Cc: Subject: Mayor
Comments on proposed Town and Country Development for July 8 Planning Commission

I am writing on behalf of a committee of neighbors to the Town and Country property at 2620 Monroe Street and the house at 665 Knickerbocker Street.

We are writing to OPPOSE the proposal scheduled for discussion at the July 8th meeting of the Planning Commission from Fred Rouse to demolish those properties and build a multi-story, mixed use development.

With the proposed development:

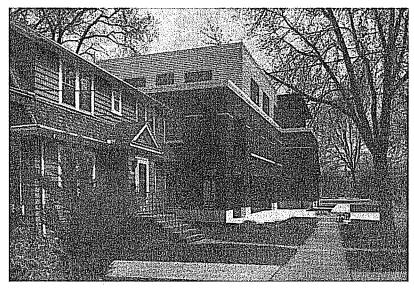
The views from the front yards of the houses on Knickerbocker Street are clearly diminished, which impacts both the enjoyment of these properties, and also their curb appeal.
